SEWAGE DISPOSAL SYSTEM
HOWARD COUNTY HEALTH DEPARTMENT
BUREAU OF ENVIRONMENTAL HEALTH
410-313-2640

SUBDIVISION Spring Hollow LOT NUMBER 22 ADDRESS 1225 Haleys Court

PERMIT

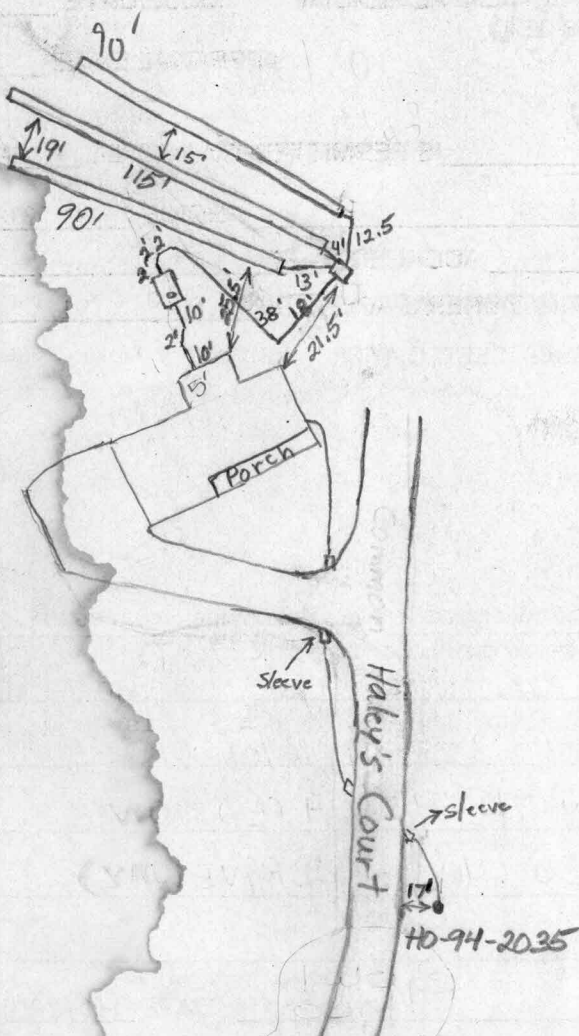
PRE-CONSTRUCTION INSPECTION: 4/12/01 layout confirmed - SDA staked - OK to install system as specified. DKC

INSPECTION COMMENTS: 4/17/01 P.M. Installer to use transit to check trench grades to assure proper installation. DKC 4/18/01 O.K. to cover first two trenches. Told installer that trenches have to be closer in future systems, regardless of trees. (BB) 4/19/01 S.T. C/O ~ 1/2' FROM S.T. EDGE; OK TO FINISH TRENCH, ADD D.B. BAFFLE & COVER (MR)
